| CARR-RESIDENCE GARAGE RECONSTR. | 24827 ROCKLEDGE RICHMOND HTS, OH |

OWNER REDLINE 10/2/26 - R. CHARLES CARR

CHANGES REQUESTED OF ARCHITECT. NOT AN ISSUED OR STAMPED DRAWING.

SECTION 1  
3/4"=1'-0"

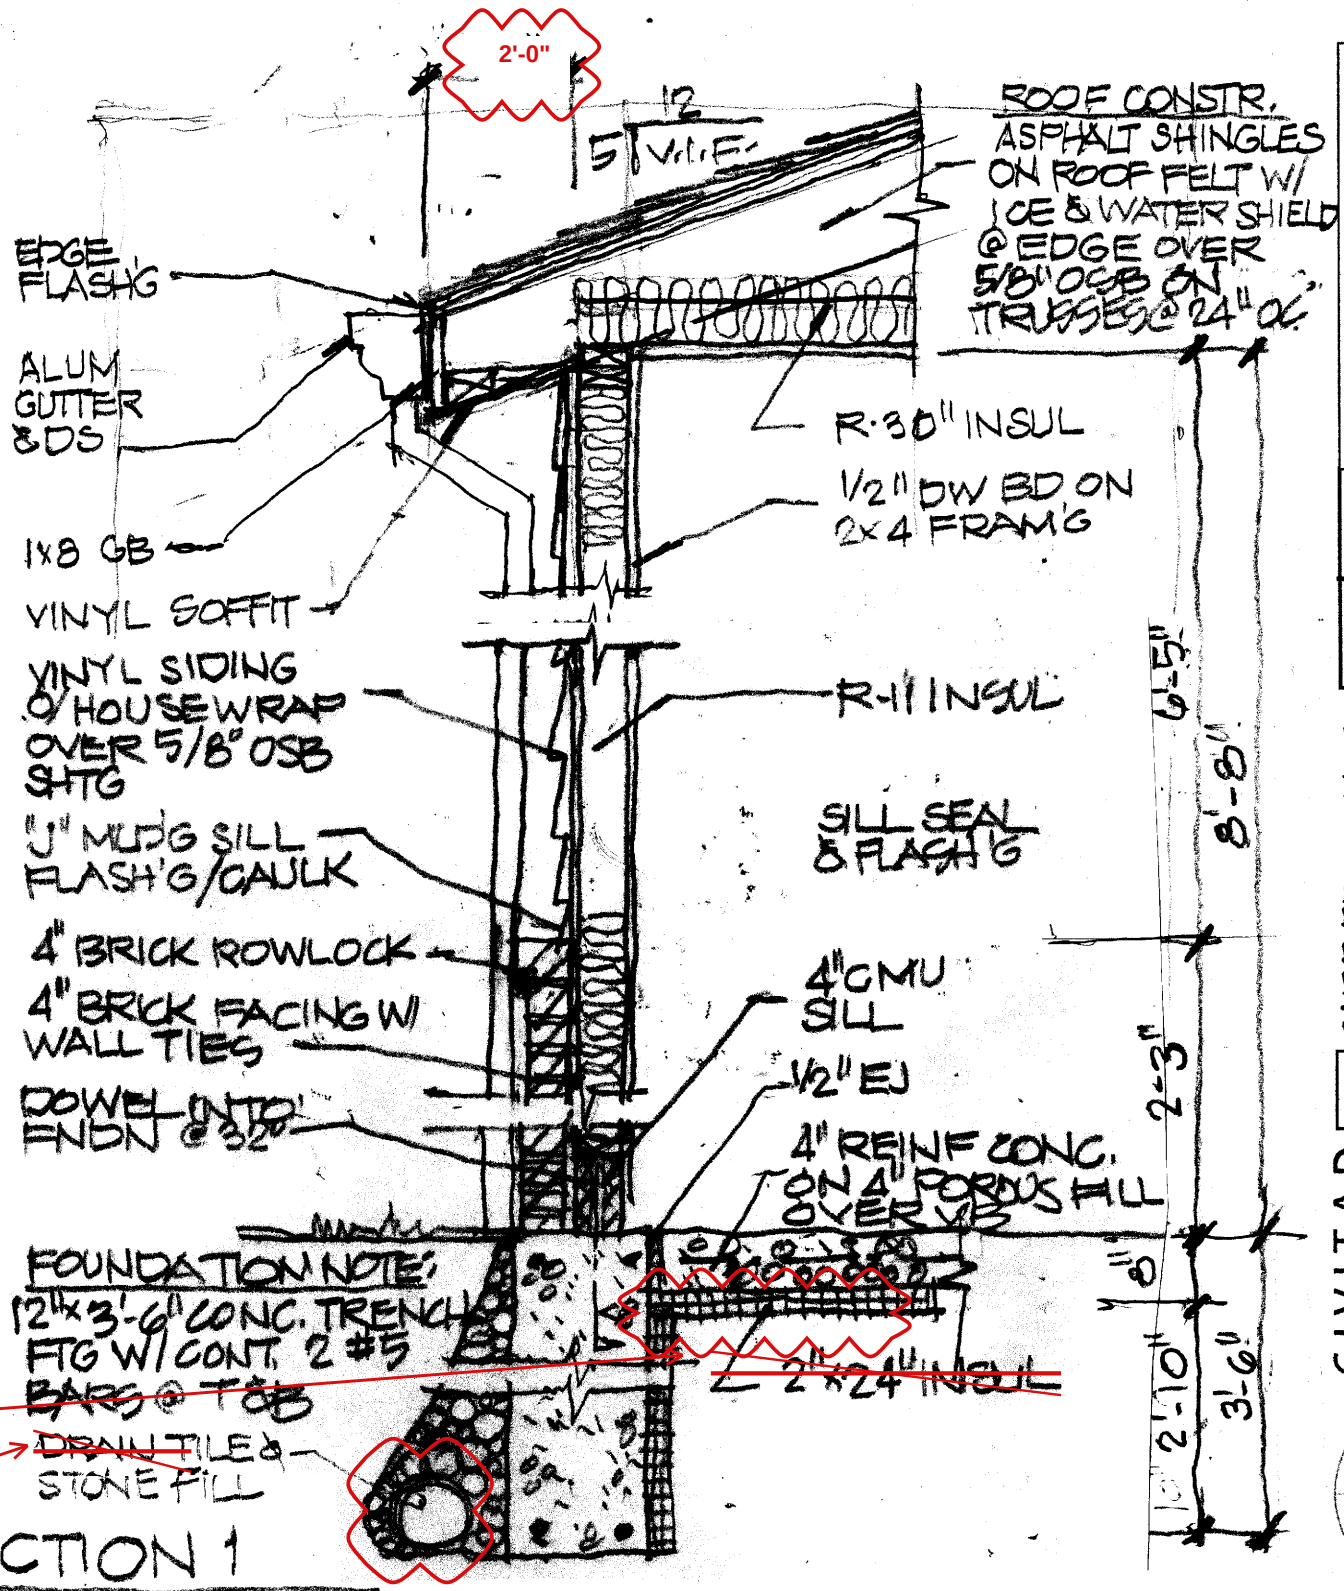
5. DELETE 2"x24" FOUNDATION INSULATION -  
NOT REQUIRED, UNHEATED GARAGE (A5, A6).  
6. DELETE DRAIN TILE AT BOTTOM OF FOOTING (A5, A6).

CROSS SECTION

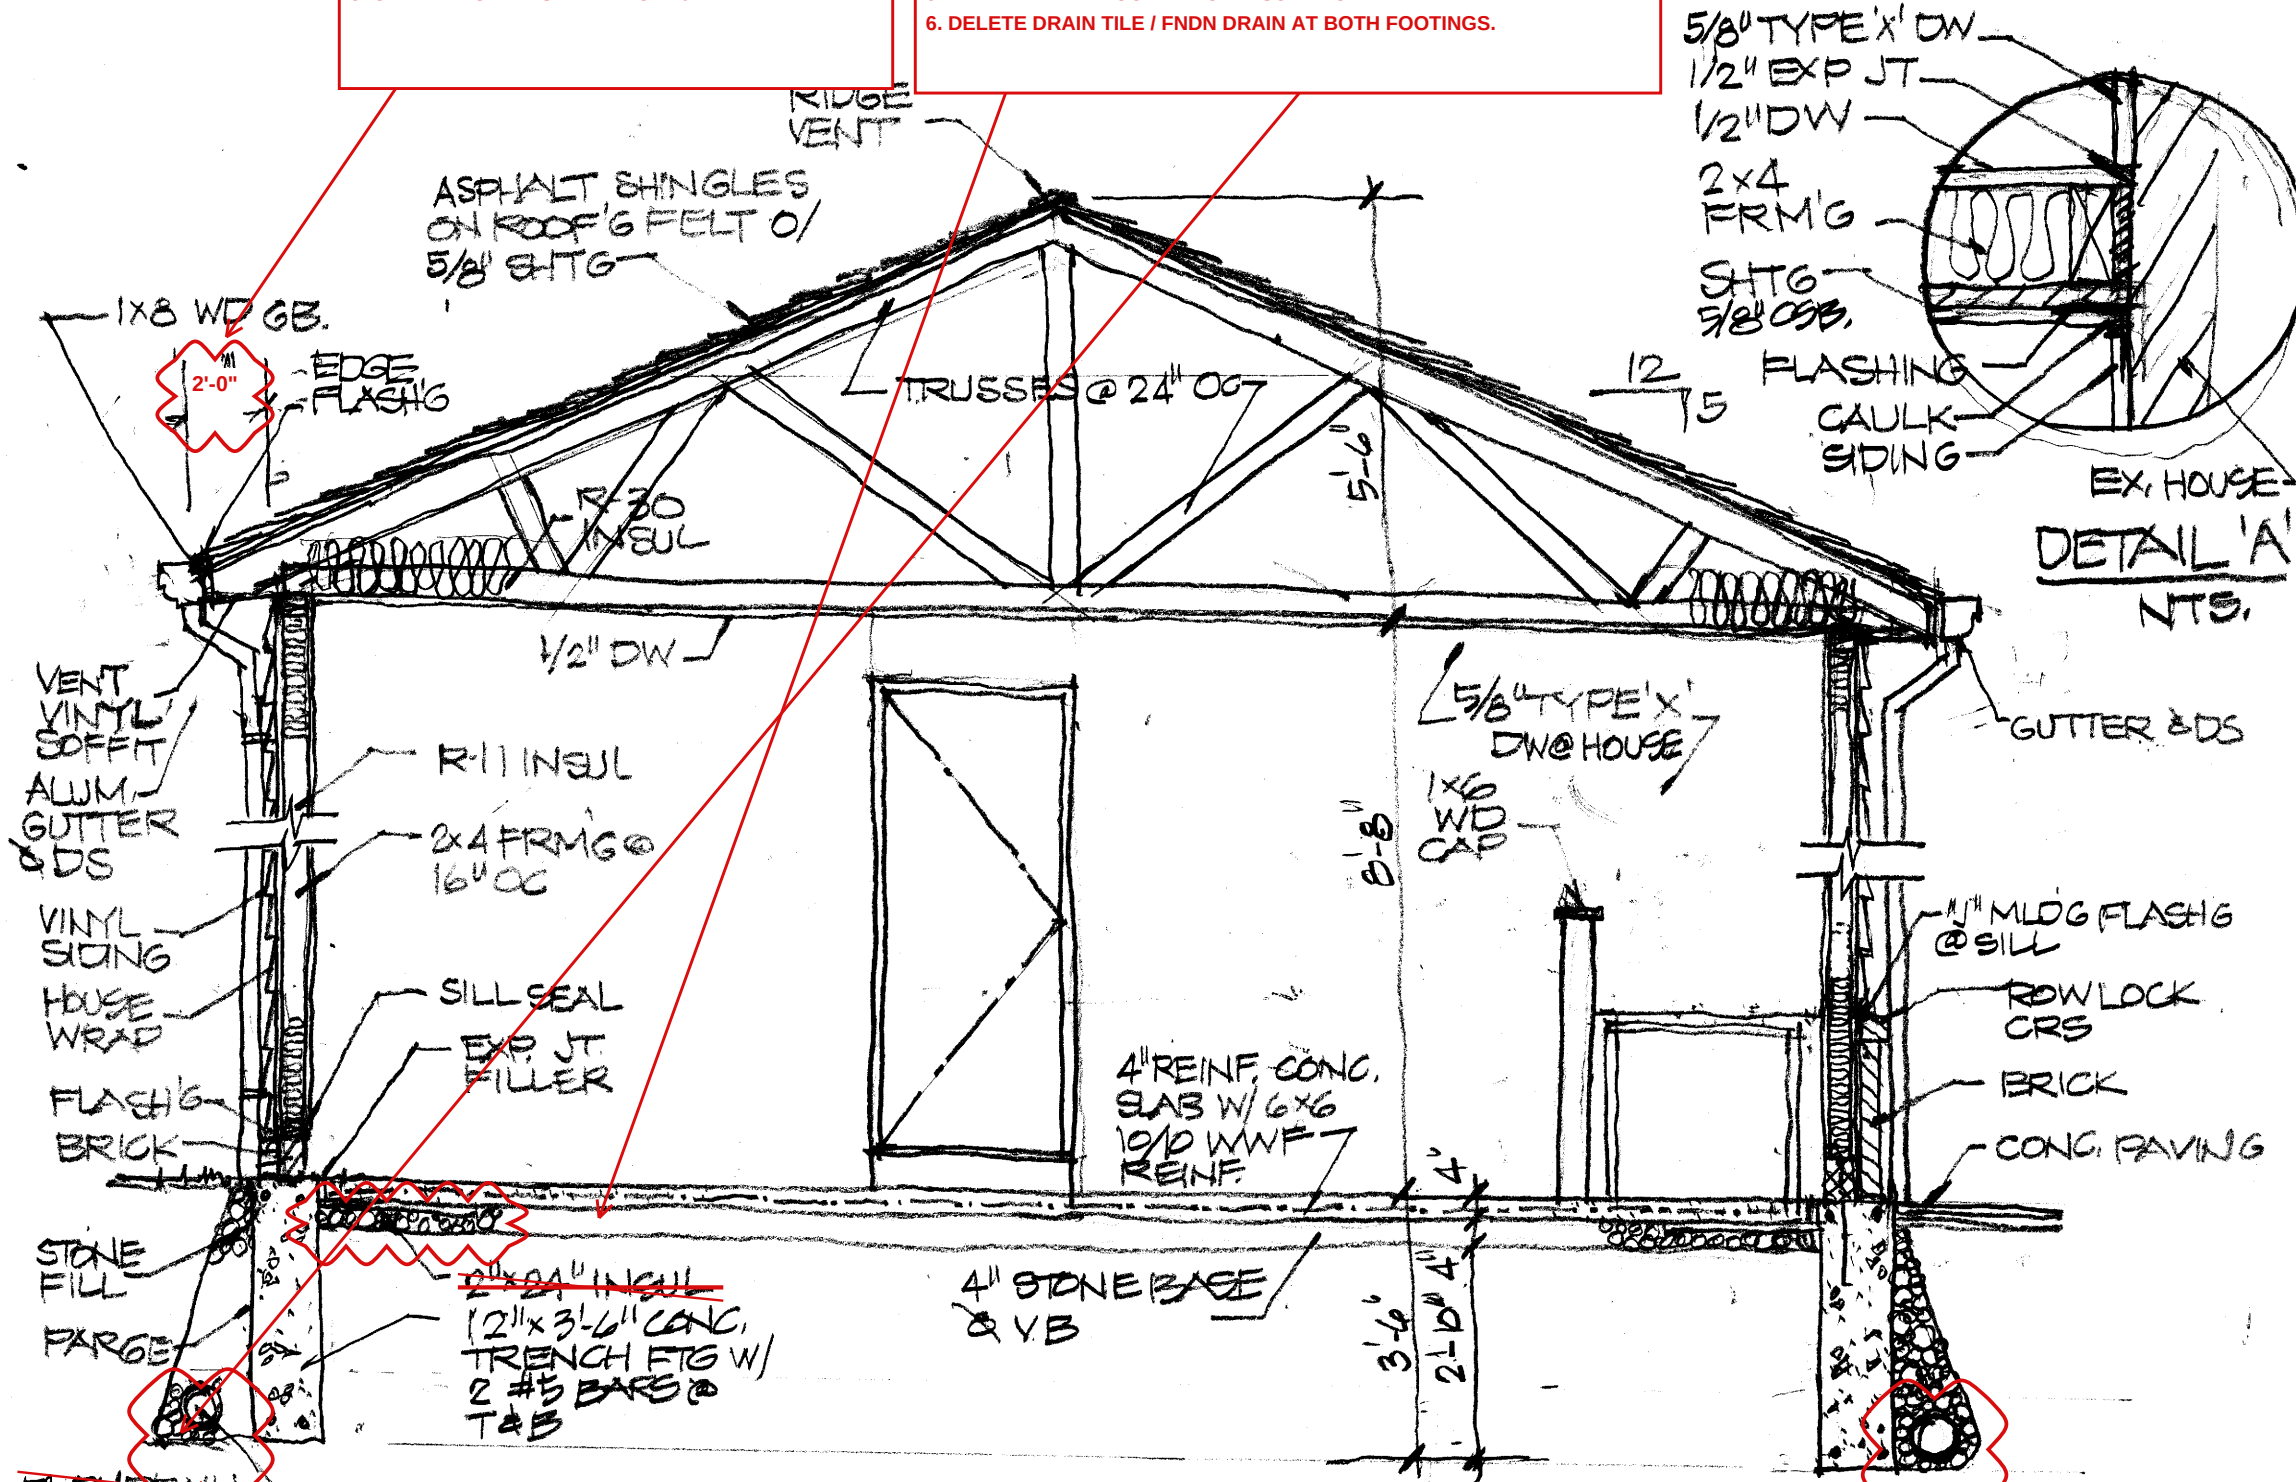
3. OVERHANG REVISED 12" TO 2'-0".

5. DELETE 2"x24" FOUNDATION INSULATION.

6. DELETE DRAIN TILE / FNDN DRAIN AT BOTH FOOTINGS.

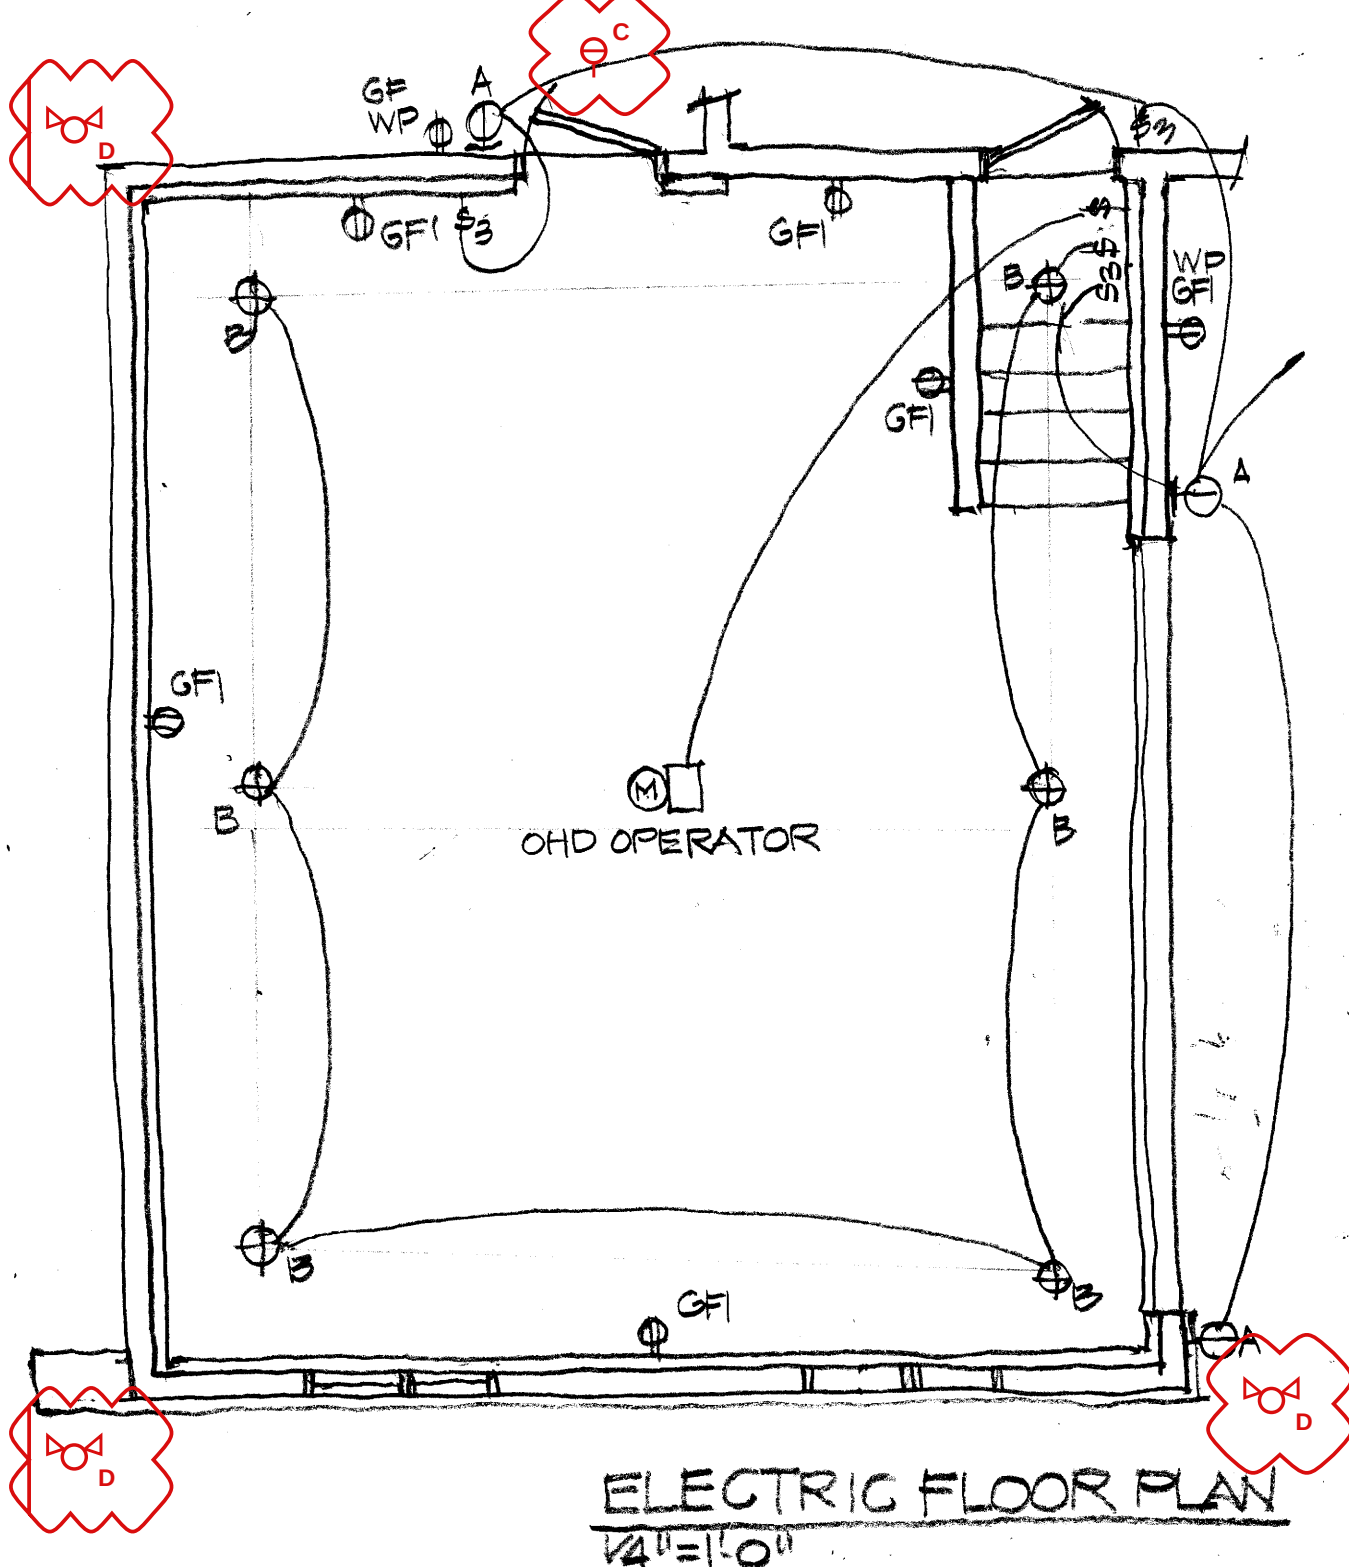
ADD TO SCHEDULE:  
D FLOOD LT, DBL HEAD W/ MOTION SENSOR, LED - EXTERIOR CORNERS: NW, SW, SE (3)  
C WALL MTD LT, LED - ABOVE EXT. MAN DOOR (1)

4. ADD 3 CORNER FLOOD LIGHTS AND 1 LIGHT ABOVE THE EXTERIOR MAN DOOR AS SHOWN. CIRCUIT TO EXISTING PANEL W/ OTHER EXTERIOR LIGHTS.
